RECALL ACTION

Recall Action
Number: P035v2

Subject: Battery Positive Cable Clash with Dynamic Response System (DRS) Pipe [UKROW-SA]	Publication No.: P035v2
	Model: Range Rover Sport (LW) - TDV6 3.0L Diesel
	Model Years: 2014
	Vin Range: LW000016 - LW323768
	Date of Issue: 24/10/2013

E161330

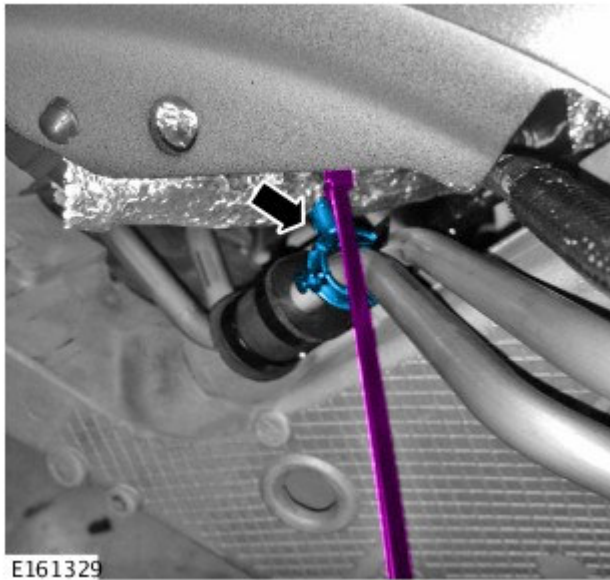
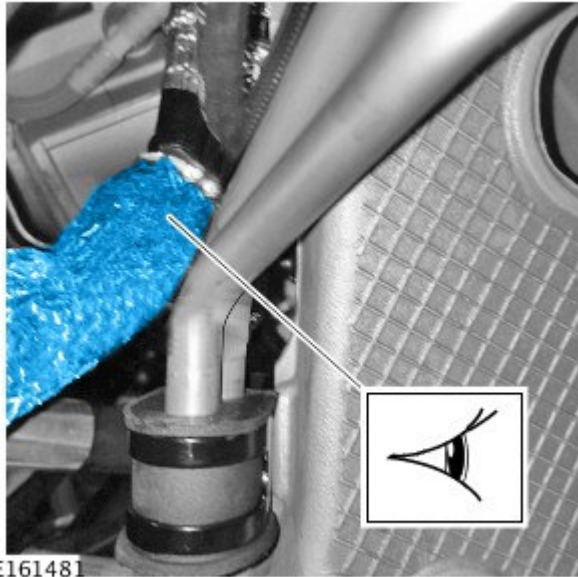
1. Remove the right front wheel arch liner (see TOPIX Workshop Manual, section 501-02).
2. Inspect the battery positive cable for any sign of damage to the cable insulation in the area of contact with the Dynamic Response Pipe.
 1. If there are signs of visible damage to the insulation, disconnect the battery and please hold the vehicle until further notice.
 2. If there are no signs of visible damage to the insulation, carry on from step 3.

3. Attach the cable tie to the battery positive cable but do not pull tight at this stage.

1. Attach the clip end to the dynamic response pipe.

4. Pull the cable tie until it is secure around the battery positive cable.

1. Cut off and discard the excess tie.
